# 2290 OLD RANCH ROAD

## LOTS 8, BLOCK E, AMENDED FILING OF SPRINGS CREST SUBDIVISION NW 1/4, SEC. 28, T.12 S., R. 66 W OF THE 6TH P.M. COUNTY OF EL PASO, STATE OF COLORADO

**DESIGNED BY:** CLE  
**DRAWN BY:** CLE  
**CHECKED BY:** CLE  
**DRAWER NUMBER:**  
**DATE:** 8/5/2019  
**SCALE:** 1" = 30'  
**SHEET NUMBER:** L1

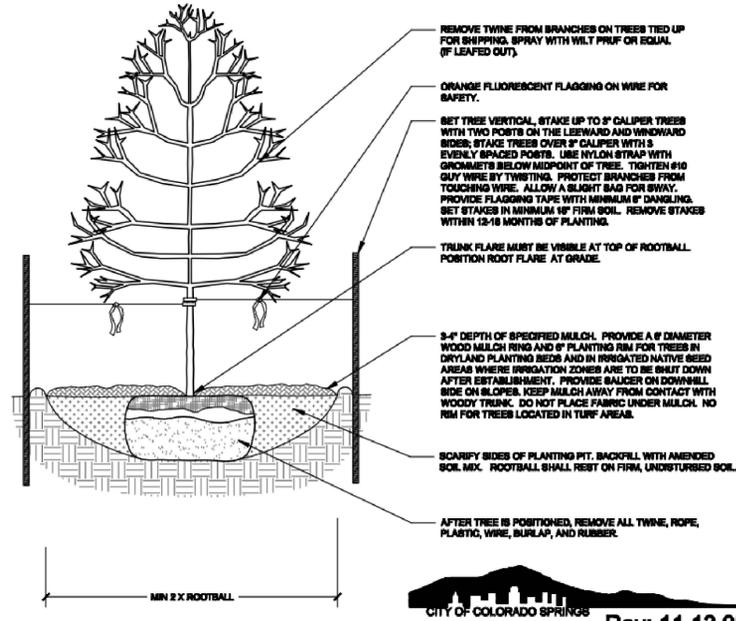
Per previous comments, please also include alternative landscaping justification on face of landscape plan.
